STAFF REPORT: OCTOBER 9, 2024, REGULAR MEETING PREPARED BY: T. BOSCARINO

**APPLICATION NUMBER:** HDC2024-00577

**ADDRESS**: 5021 TIREMAN (AKA THE BLUE BIRD INN)

SCOPE: ERECT ADDITION (CHANGES TO PREVIOUSLY APPROVED DESIGN)

Isometric drawings of previously approved addition (left) and proposed change (right). Images from 2023 and current applications, respectively.

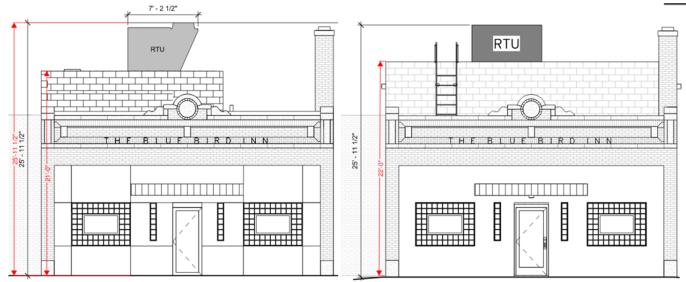
The submitted application materials proposed to enlarge the floor area and volume of the previously approved addition. The height of a parapet wall would also increase by one foot (see measured elevations on next page), though the roof and rooftop HVAC unit height would not change.

The placement of the proposed HVAC equipment at the highest point of the building is a potential concern, as it may be visible from some vantage points. However, the application states that this is a deliberate choice due to interior acoustic considerations. The application also states that the equipment will not be visible from Tireman Avenue.

• In staff opinion, the increased parapet height of 1'0" is does not substantially change the appearance or appropriateness of the proposed addition. Due to the depth of its setback, it would remain minimally visible from the street. The roof height and the height of the rooftop HVAC unit remain the same.

Staff recommends that the Commission issue a Certificate of Appropriateness, as the proposed work meets the Secretary of the Interior's Standards for Rehabilitation and the Elements of Design for the Blue Bird Inn Historic District, with the condition that

• The specification of brick veneer or visible concrete masonry units to be used on the addition shall be subject to approval by staff.
